PORT BOTANY EXPANSION

RAIL OPERATIONS

SECTION 96 (1A) MODIFICATION

February 2009

Figure 1: Approved Development (From URS, 2003)

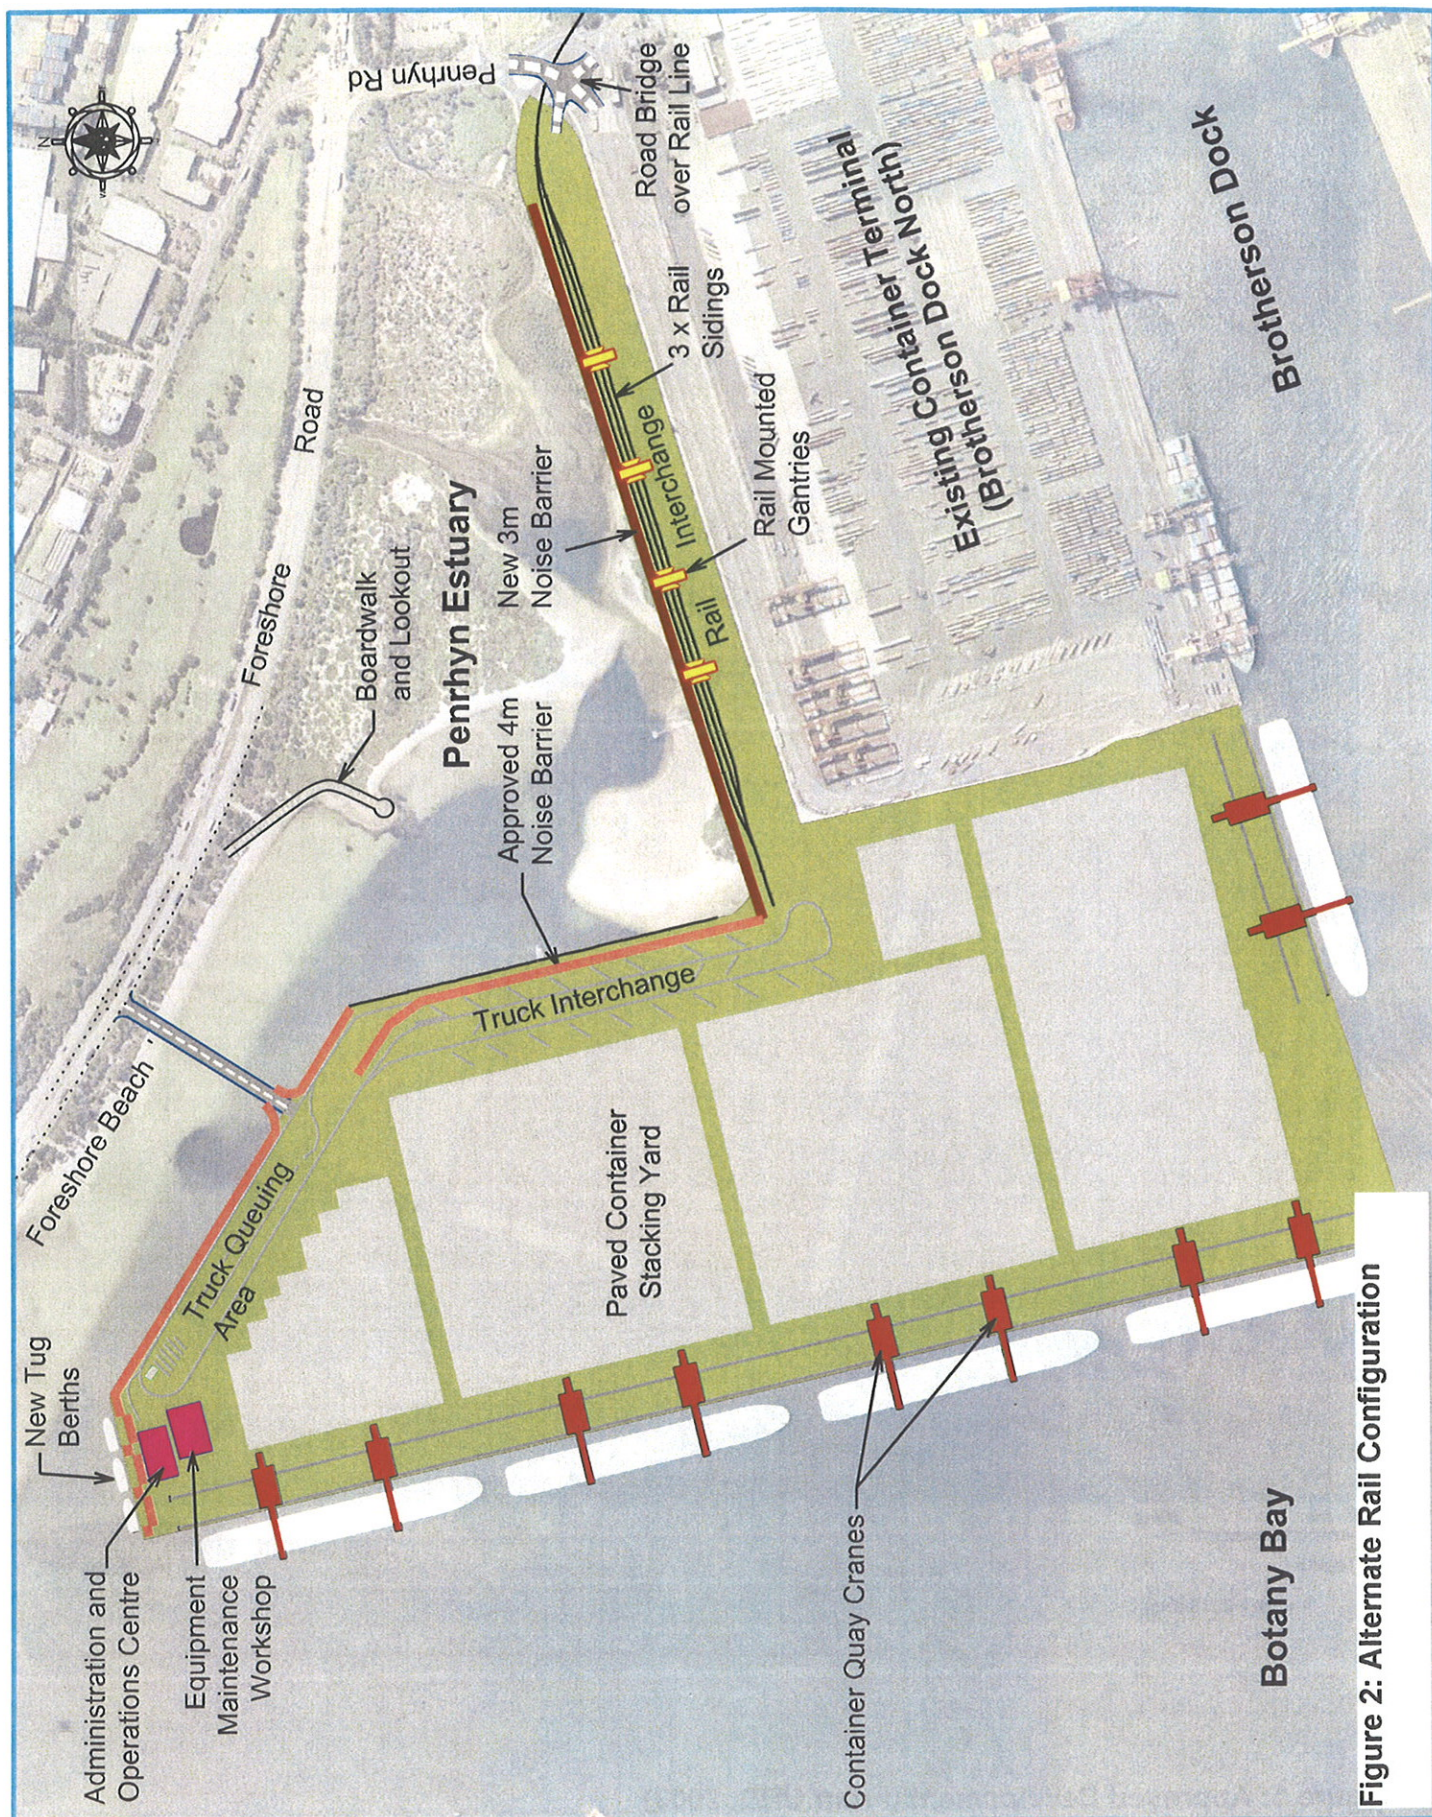
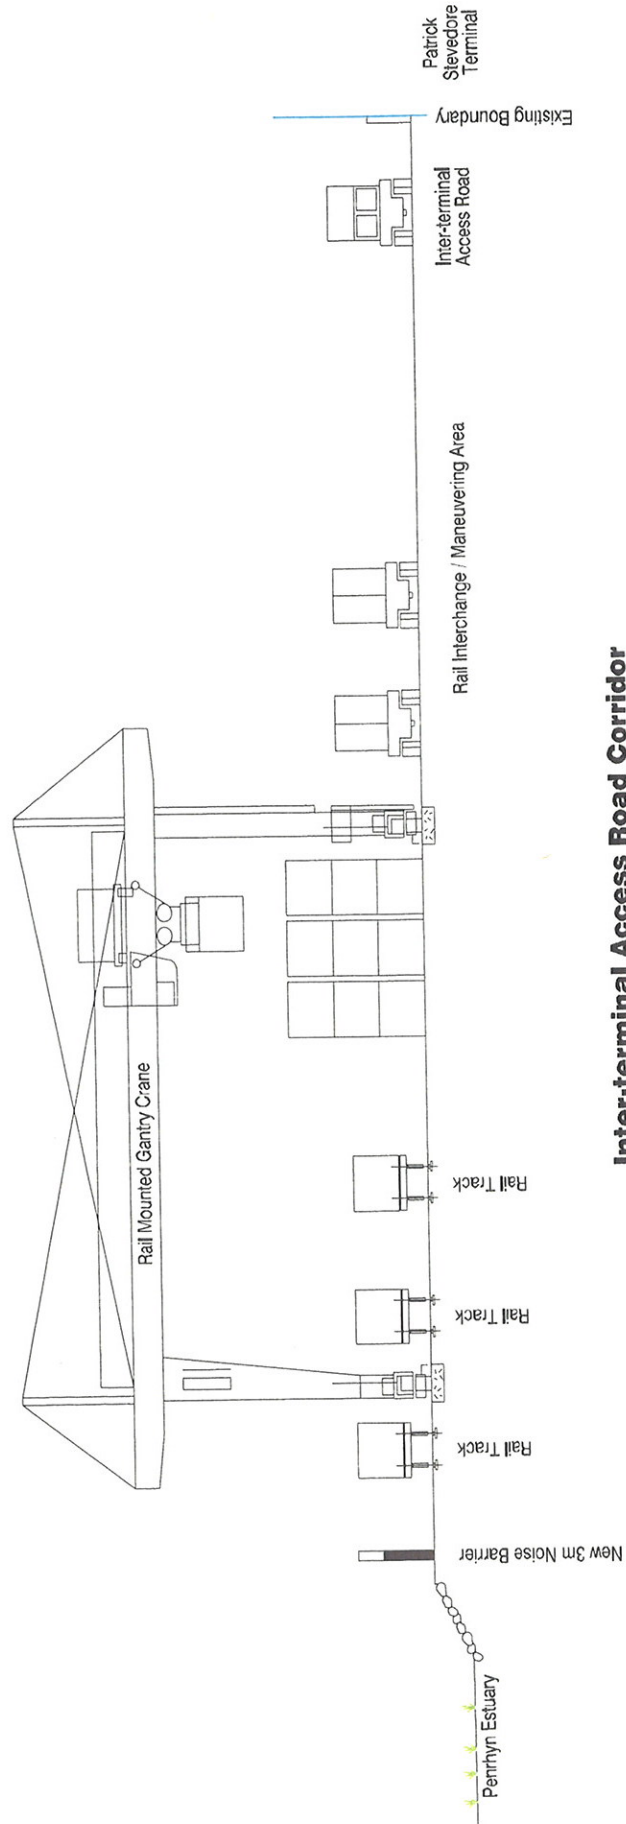
Figure 1.2 of the EIS, reproduced below, identifies the approved rail configuration. This modification application seeks to retain the approved rail configuration as one option in the event that the new terminal is leased entirely to one operator.

In order to achieve 600m operational rail sidings for the northern portion of the new terminal, operational rail activities would need to take place along the Inter-terminal Road Access Corridor, in place of the approved rail storage sidings. This is identified in Figure 2 below.

This modification application seeks approval to construct three rail sidings of 600m length on the Inter-terminal Access Road Corridor for the unloading / loading of containers to/from rail, as an option. A 3m high noise barrier will be constructed north of the rail sidings, with the top 1m being made from transparent material.

Figure 4: Additional Area of Groundcover Vegetation

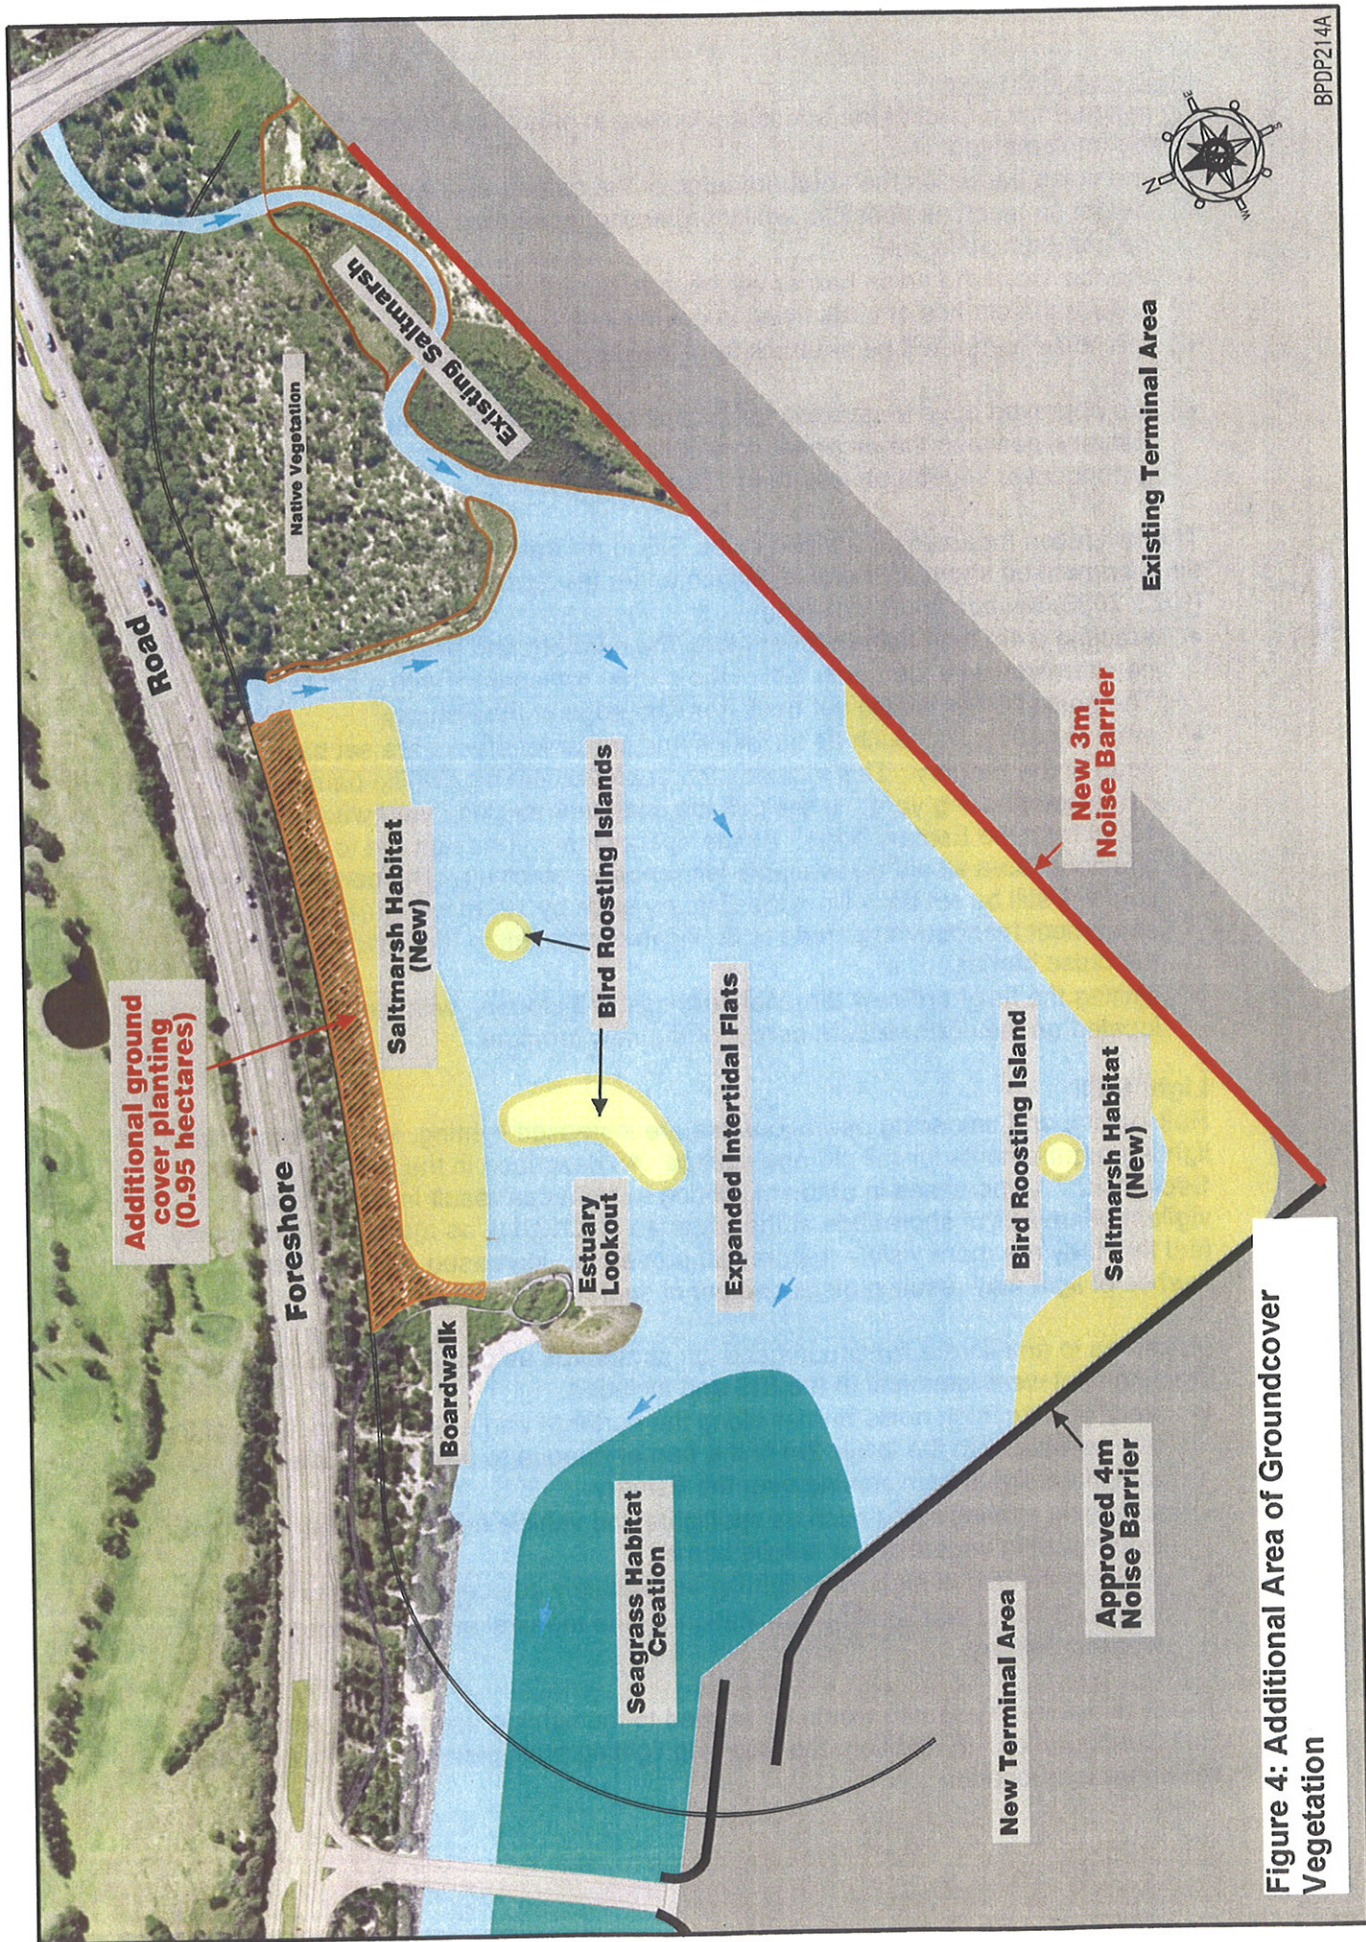
1. to replace dune vegetation landscaping along the northern side of Penrhyn Estuary, between the proposed lookout and Floodvale Drain, with groundcover vegetation less than 15cm in height. (Refer Figure 4) This increases the clear view around the habitat and therefore increases the area of habitat in the northern part of Penrhyn Estuary which will be used by shorebirds. The groundcover vegetation will extend back from the Estuary across the rail corridor, a width of about 33m, as the rail in this location, under the Alternative Rail Configuration, would no longer be required. There is still sufficient landscaping beyond this to screen Foreshore Road. The area of groundcover vegetation to be planted is about 0.95 hectares.
